# Asteroid-Z MS-7423N1

Version 10

MS-7423

Rev 10

# CLOCK Generator - IDTCV184-2

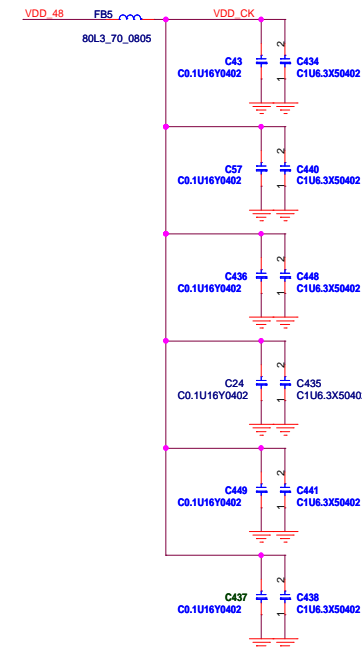
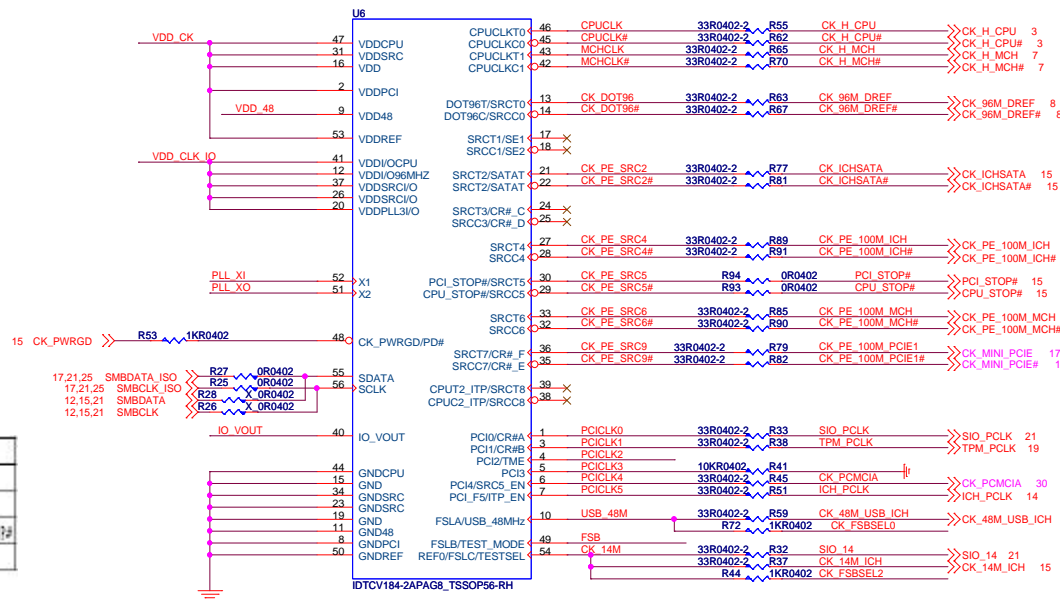
C28, C29 are changed from 27pF to 47pF for 0B

Eaglelake Memory

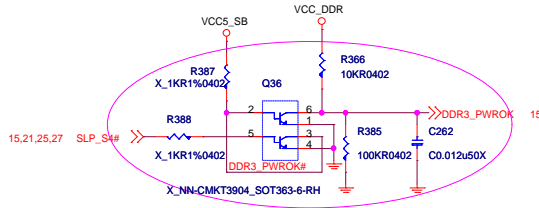
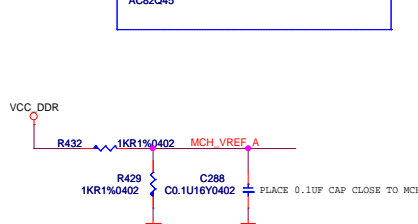
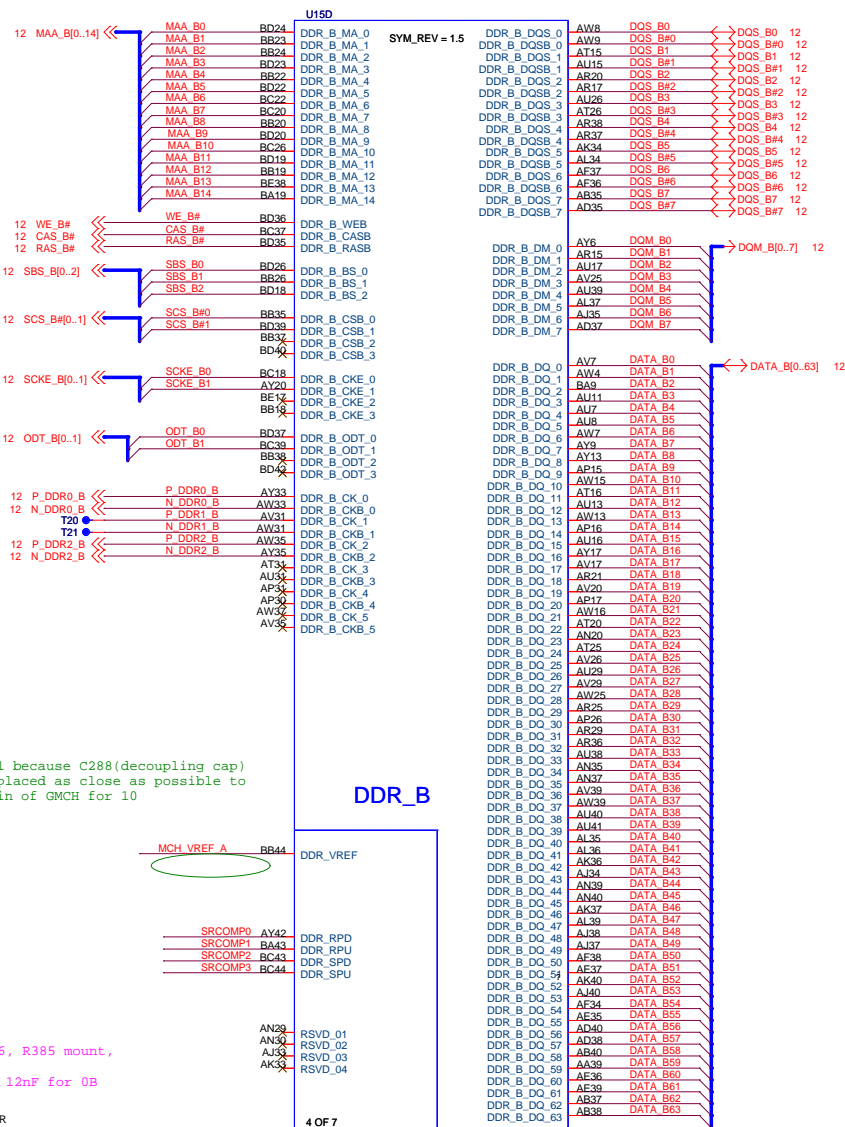
remove C291 because C288(decoupling cap)  
should be placed as close as possible to  
DDR\_VREF pin of GMCH for 10

remove Q54, Q56, add Q36, R385 mount,  
R387& R388 not mount  
C262 change from 1uF to 12nF for 0B

C287 change from Y5V to X7R;  
C290 change from 0603 type/Y5V to 0402 type/X7R for 0B

# POWER

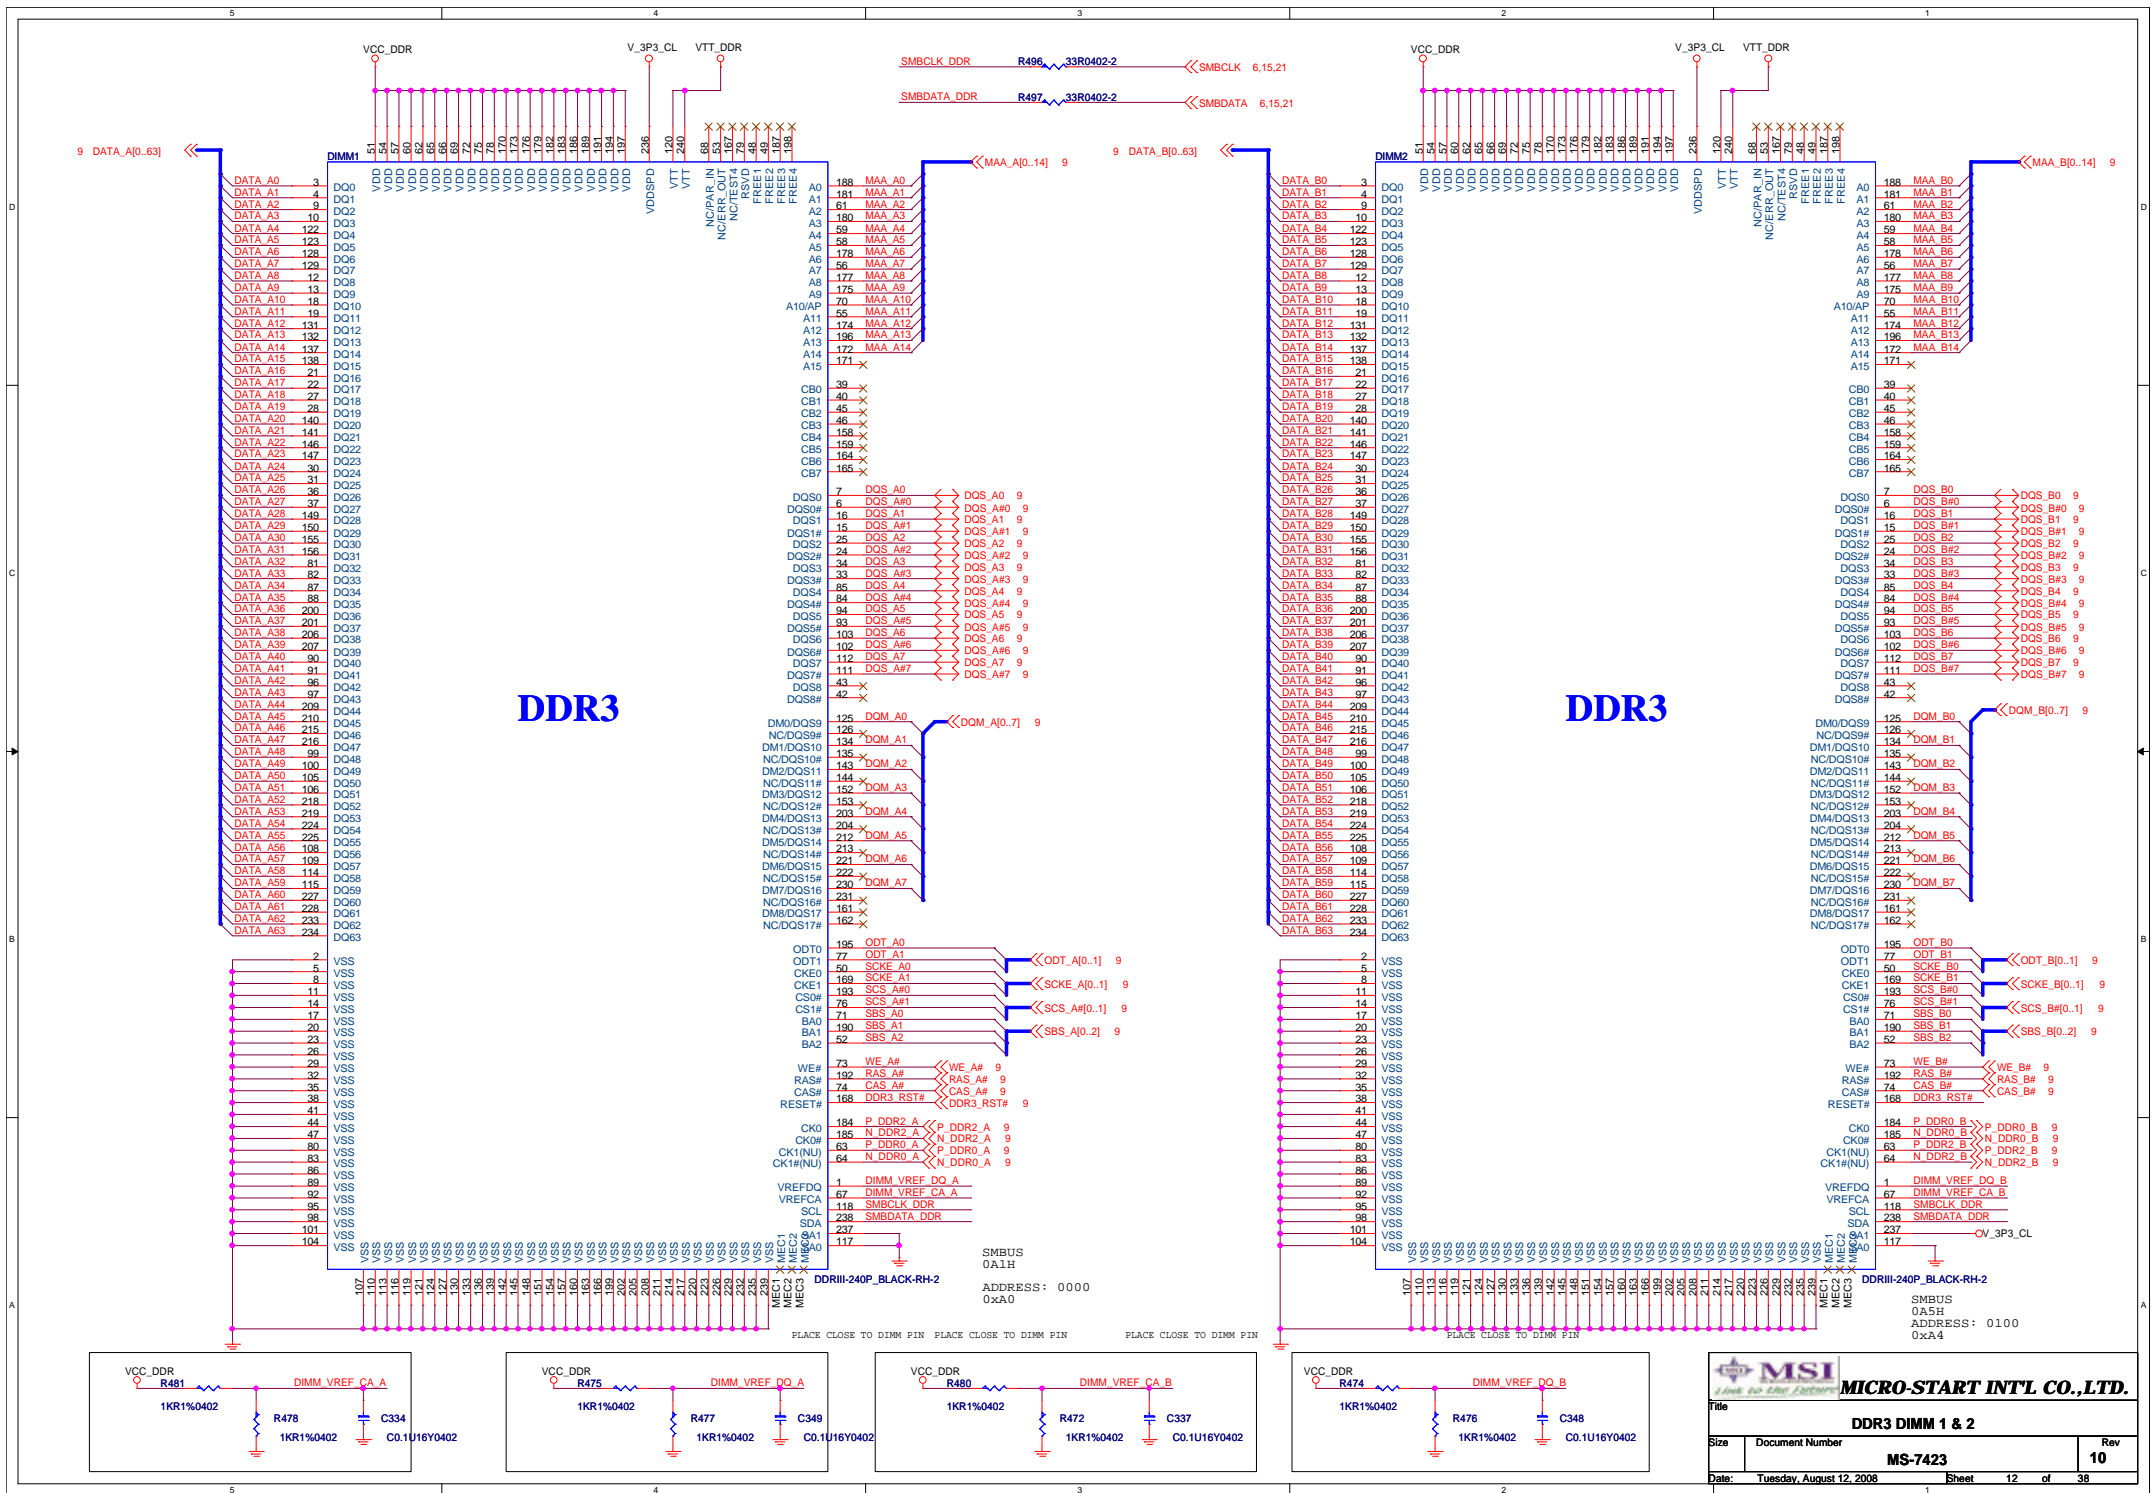
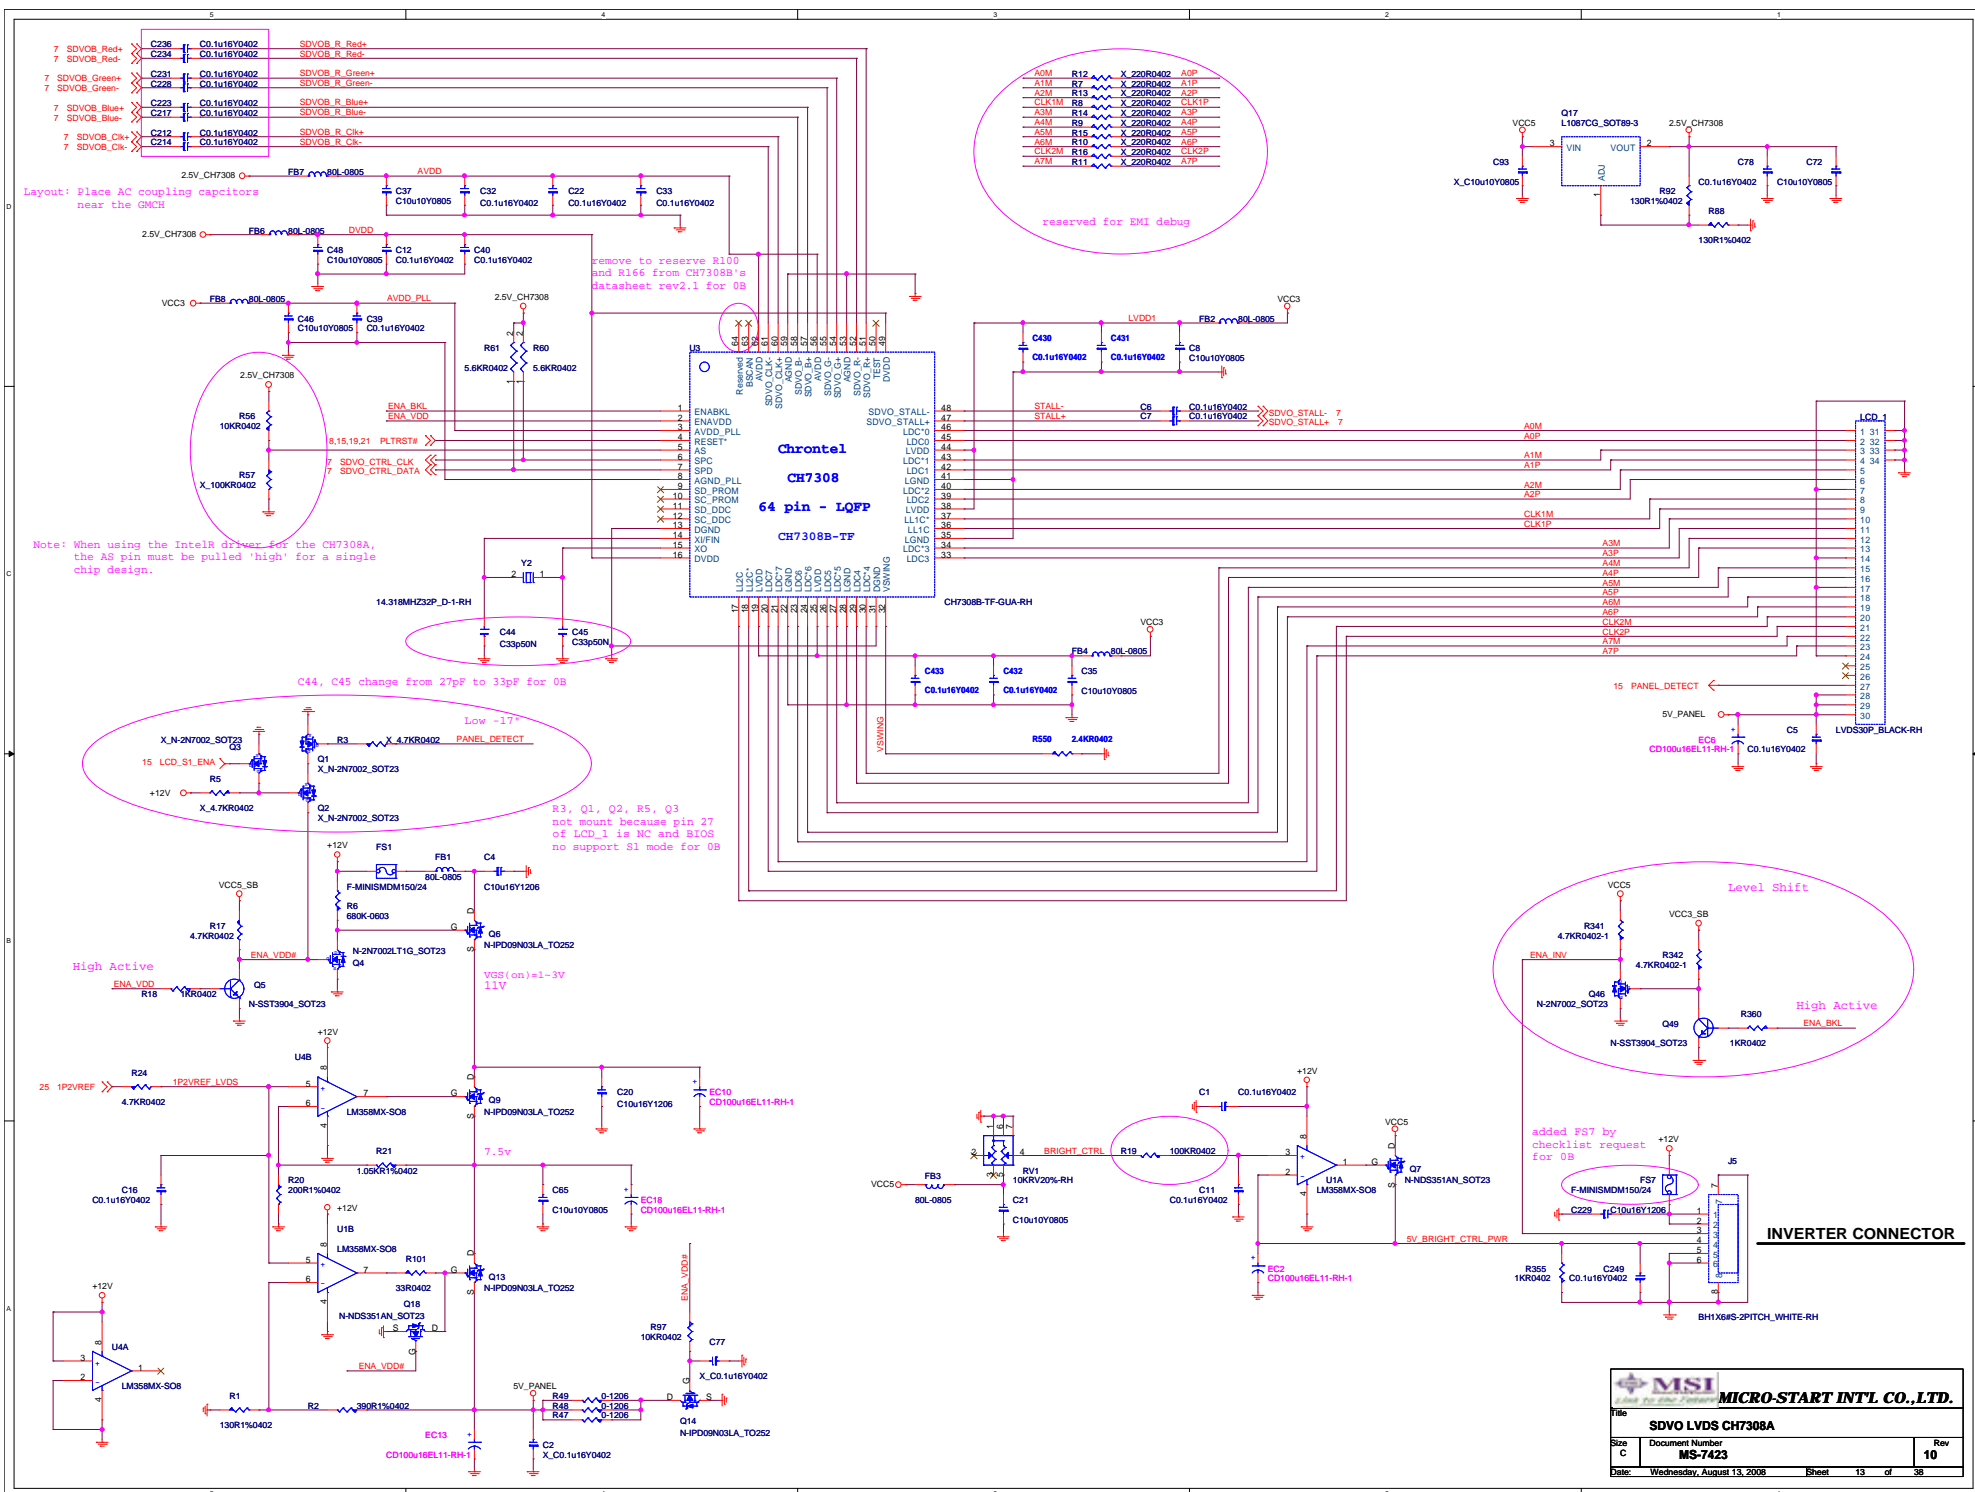
Power name change from  
V\_1P1\_CORE to  
V\_FSB\_VTT for 0C

# 5VREF & 5VREF\_SUS Sequencing Circuit

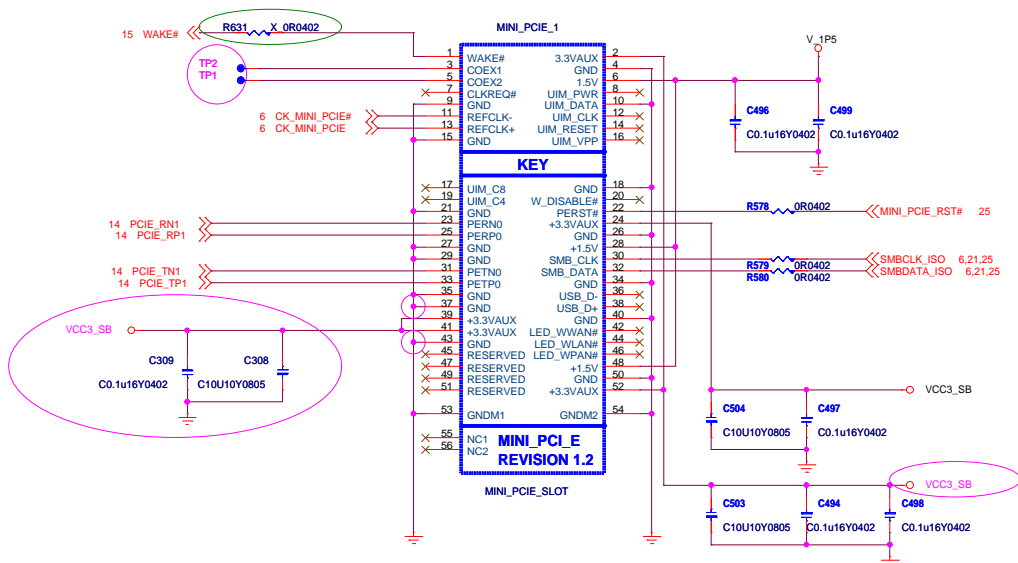
Intel recommends using a pull up resistor of 100ohm (R391) to VCC5\_SB together with the 1uF X7R capacitor (C268). The change is to avoid a high ramp up rate on 5VSB (V5REF\_SUS) from WW23 MOW for 0C

## MINI PCI-E BLOCK

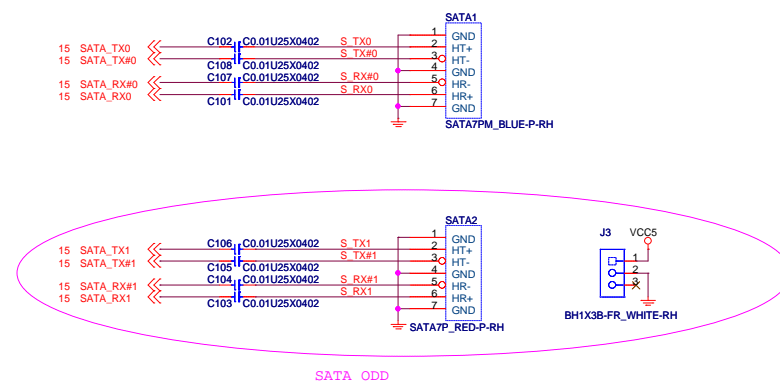
Reversed R631 by customer request because Asteroid-Z doesn't support WOL on WLAN card for 1.0 on 8/5

<b>MICRO-START INT'L CO.,LTD.</b>	
Title	
TPM/FAN/LPC Debug Port	
Size	Document Number
Custom	MS-7423
Date:	Tuesday, August 12, 2008
Sheet	19 of 38
Rev	10

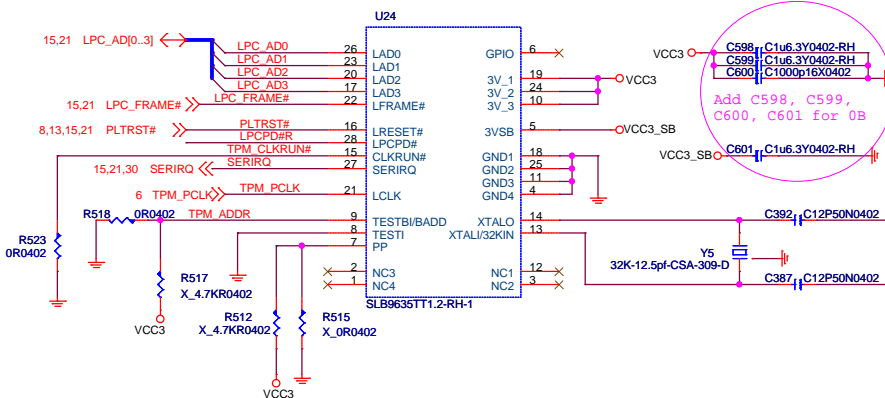
The four decoupling capacitors should be placed as short as possible to the respective 3V and 3VSB pins of the chip.

added R624 and reversed R623 for OC by Infineon' s suggestion on 06/09

For 0C

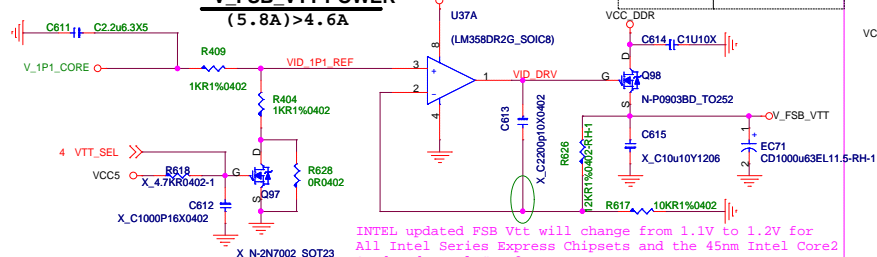
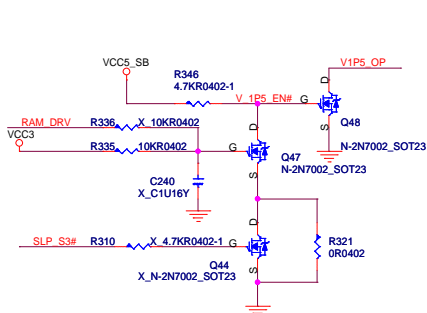
C611 is changed from 2200pF to 2.2uF; R409 is changed from 2.7K ohm to 1K ohm 1%; R404 is mounted 1K ohm 1%; added 0ohm to R628; added 12Kohm 1% to R626; R617 is changed from 10Kohm to 10K ohm 1% by E0 stepping of CPU for 1.0

INTEL updated FSB Vtt will change from 1.1V to 1.2V for All Intel Series Express Chipsets and the 45nm Intel Core2 Quad and Intel Core2 Duo processors.

V1P5\_SEN S3 power sequency

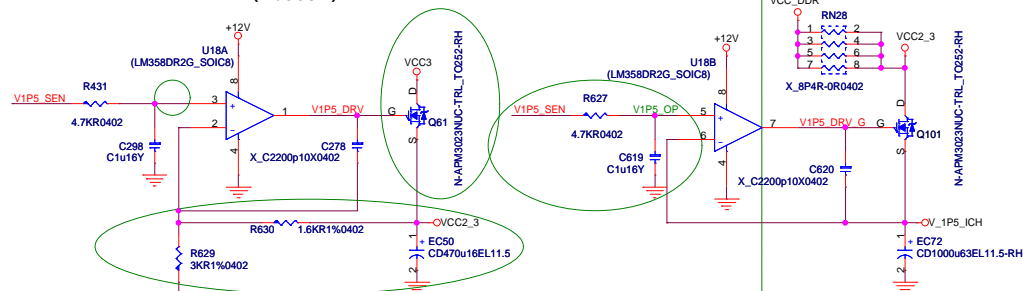
There would be solved by CPUPWRGD glitch when S0 to S5 for 1.0 modification

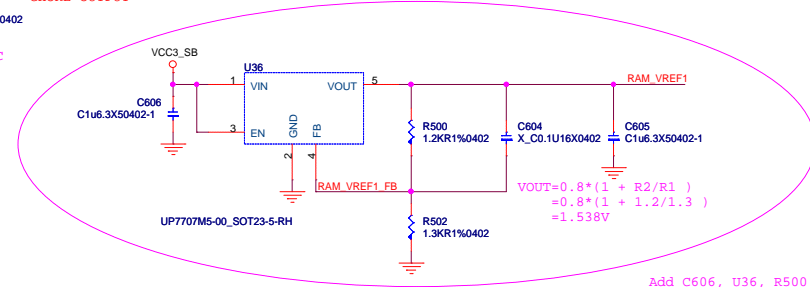
EC62 change from 1000uF to 820uF for 0B

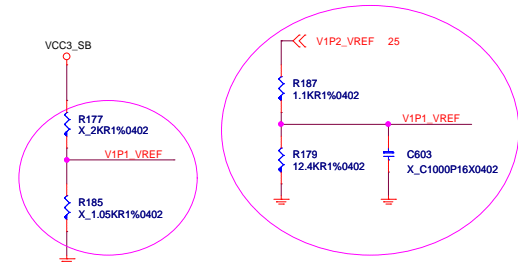
Add C606, U36, R500, R502, C605, reserve C604 for 0B

R177, R185 not mount; mount 1.1K $\Omega$  to R187; mount 12.4K $\Omega$  to R179, reverse C603 for 0B

## Front Panel

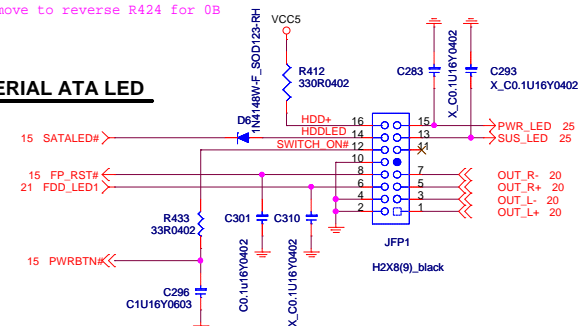
remove to reverse R424 for 0B

## EMI decoupling cap

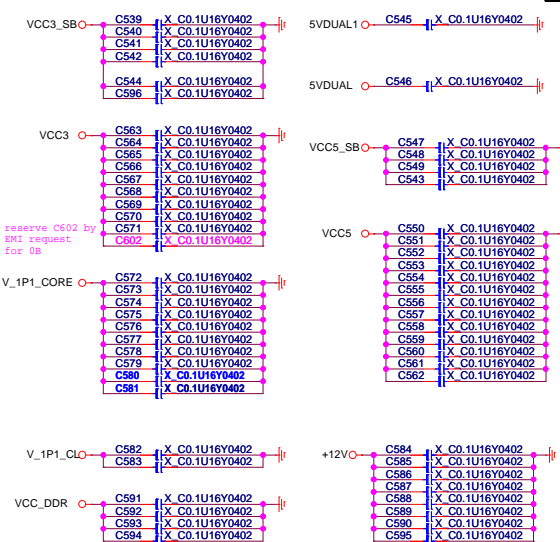
reserve C616, C617, C618 by EMI request for 0C
